COMBUSTION PROBLEMS IN
ORR AND SIMBOWER INCORPORATED
800 lbs/hr AUXILIARY BOILER
(MSO CLASS)

NBTL Project B-471
Final Report

A Research and Development Report
BUSHIPS Project No. S-F013-08-12
BUSHIPS Task No. 4172

Encl: (1) NBTL SK. #4588 of final burner-air nozzle modification

FINAL MODIFICATION TO BURNER-AIR NOZZLE

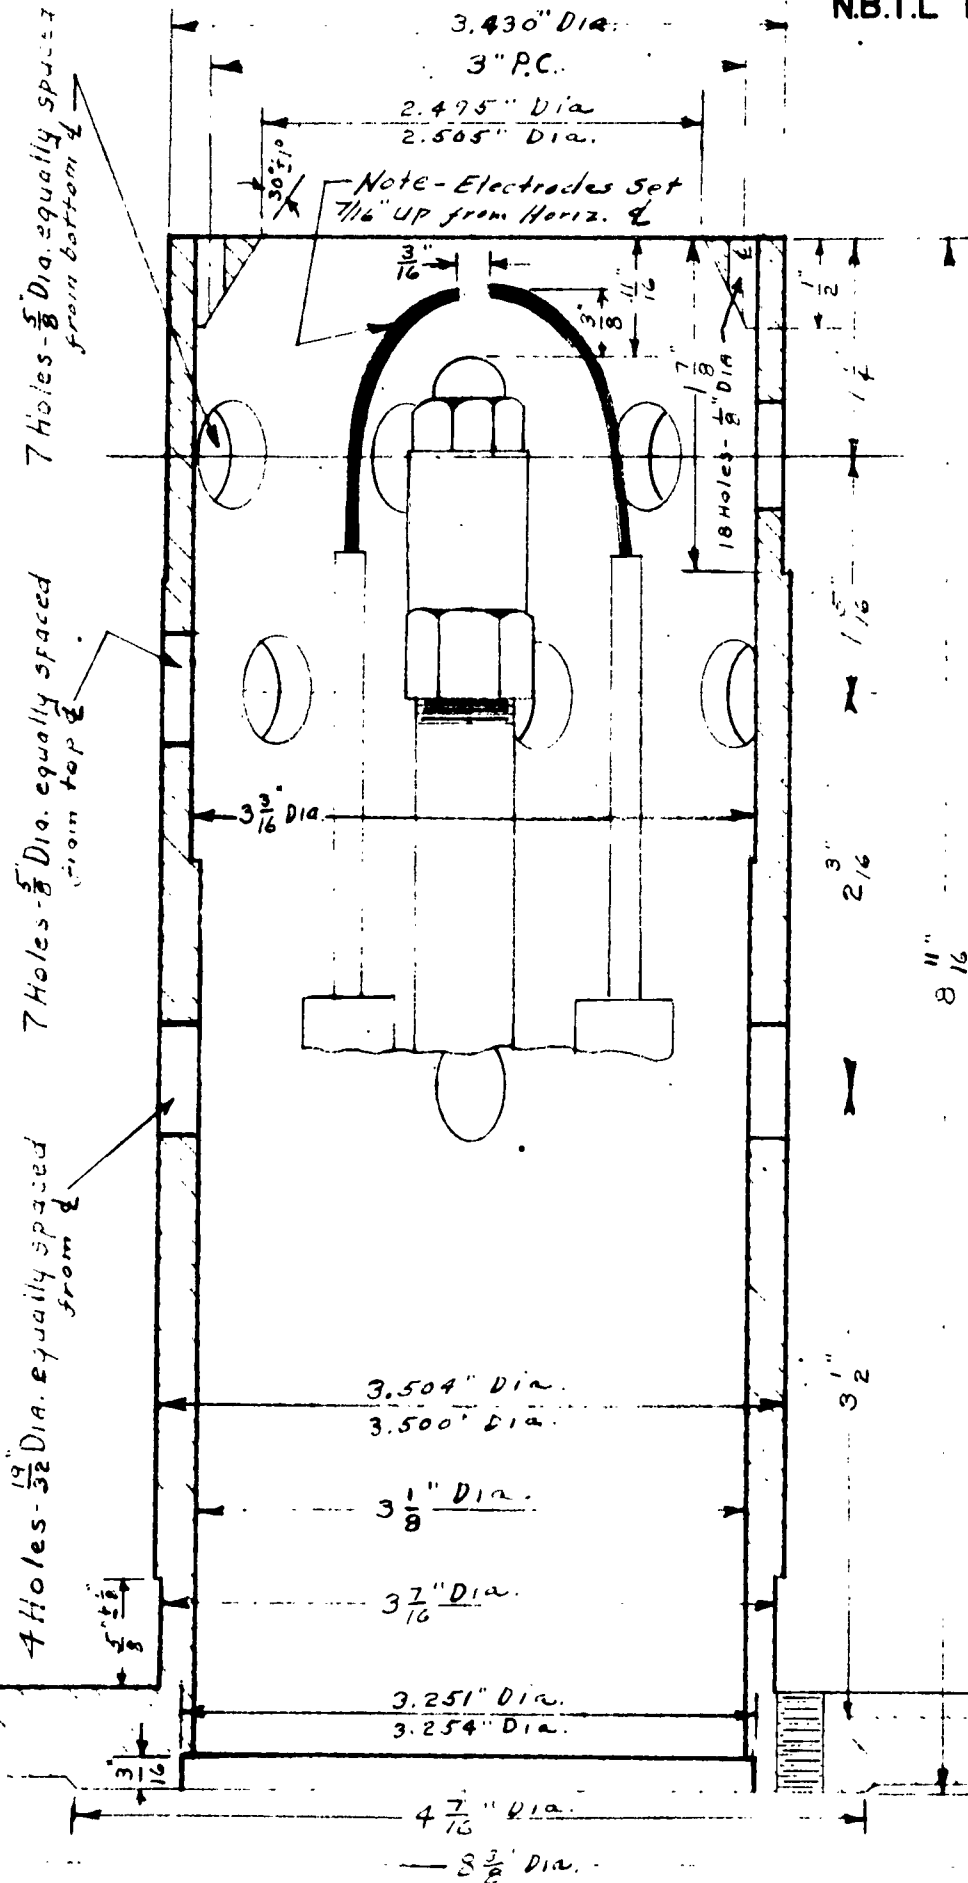
7. It is recommended that burner modifications be made on each boiler of the subject type now in service so that all units will agree with enclosure (1). The burner as shown in enclosure (1) differs from that shown in reference (c) as follows:

a. The first inlet row of $1/2$ inch holes in the burner air nozzle has been eliminated.

b. The original second inlet row becomes the first row and is made up of four $19/32$ inch diameter holes instead of seven $5/8$ inch holes.

c. The outside diameter of the burner air nozzle exit end is reduced 0.010 inches to 3.430 inches.

d. The burner oil tube is $3/16$ of an inch longer making the distance between sprayer plate and end of nozzle $11/16$ of an inch.

e. Ignition electrodes were set $7/16$ of an inch from horizontal center line of burner tip edge.

In addition, drawings should be changed as well as technical manuals to assure proper burner arrangement and, therefore, improve combustion performance in the future.
